DE LA VEGA
PRELIMINARY OVERALL DEVELOPMENT PLAN
A REVISION TO APPROVED P.O.A.D.P. No. 721,

City of San Antonio
Planning Department
Master Development Plan Section
APPLICATION

This letter is in reference to the above identified preliminary overall development plan. We have received your comments and our response is as follows:

PROPOSED COLLECTOR STREET SECTION

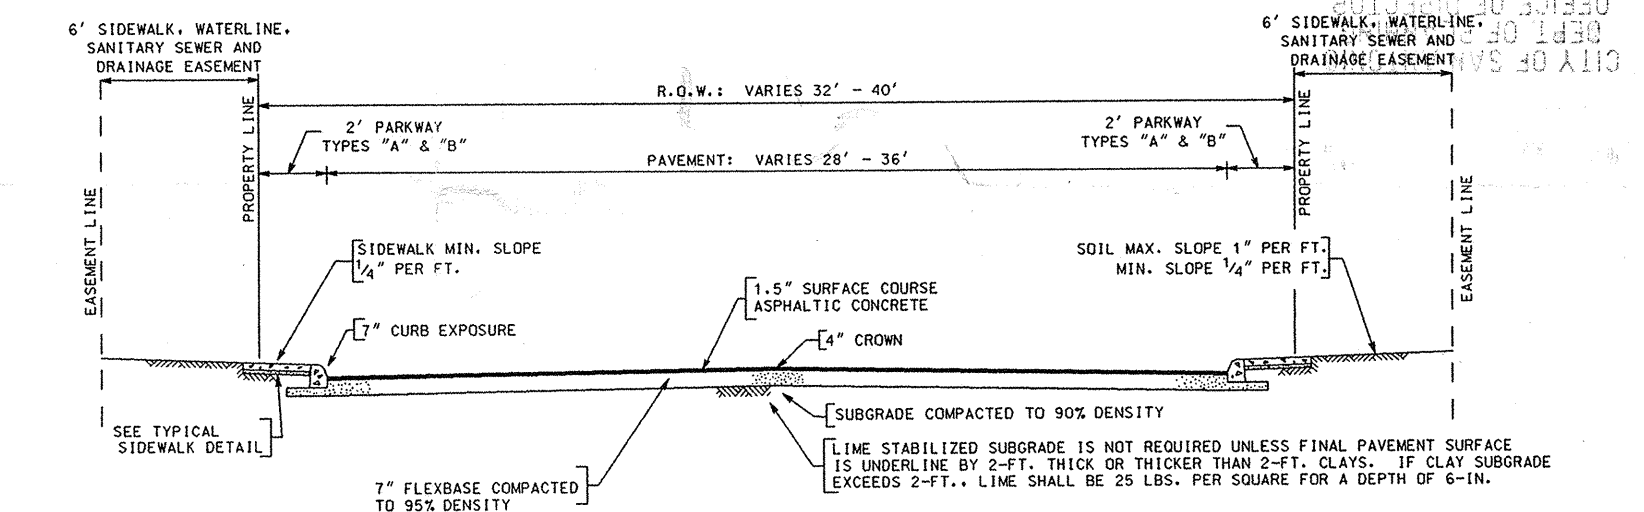
PROVIDE DIMENSIONS ON THE COLLECTOR STREET

PROVIDE STREET SECTION FOR LOCAL "A"
